# Access Compliance Report

## Public Rights-of-Way

### (Curb Ramps)

Intersection ID: 54219	Main Street: SANDY_ROCK_PL	Cross Street: NORTH_REA_PARK_LN	Location: SE
ADA ID: E146A84D7C7F	Ramp Type: Perp	Initial Pass/Fail: Fail	Overall Compliance: No
Severity Score: 1.25			
Codes/Mitigation Info/Possible Solution		Field Measurements/Component Compliance

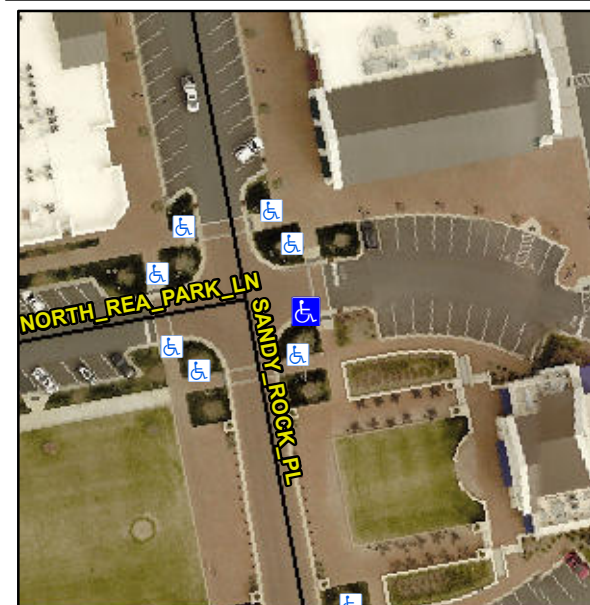
**Not Found, R304.5.3**

Compliance	Description	Data	Compliance	Description	Data
N/A	Ramp Length (in)	87.0	Yes	Ramp Slope (%)	8.1
Yes	Ramp Width (in)	94.0	No	Ramp XSlope (%)	2.4
N/A	Flare Type LT	N/A	N/A	Flare Type RT	N/A
N/A	Flare Slope LT (%)	N/A	N/A	Flare Slope RT (%)	N/A
N/A	Flare Traversable LT?	N/A	N/A	Flare Traversable RT?	N/A
N/A	Landing Length (in)	N/A	N/A	DWS Provided?	N/A
N/A	Landing Width (in)	N/A	N/A	DWS Contrast?	N/A
N/A	Landing Slope (%)	N/A	N/A	DWS Length (in)	N/A
N/A	Landing X Slope (%)	N/A	N/A	DWS Full Width?	N/A
N/A	Landing Curb? (Y/N)	N/A	N/A	DWS Offset (in)	N/A
N/A	Shared Landing?	N/A			
N/A	Gutter Ponding?	N/A	N/A	Gutter Slope (%)	N/A
N/A	Gutter Lip Ht (in)	N/A	N/A	Gutter X Slope (%)	N/A
N/A	Painted X Walk1?	Yes	N/A	Painted X Walk2?	N/A
	X Walk 1 Direction	To N		X Walk 2 Direction	N/A
N/A	X Walk 1 Width (in)	78.0	N/A	X Walk 2 Width (in)	N/A
	X Walk 1 Slope (%)	1.3		X Walk 2 Slope (%)	N/A
	X Walk 1 X Slope (%)	2.0		X Walk 2 X Slope (%)	N/A

**Remove & Replace Entire Ramp.**
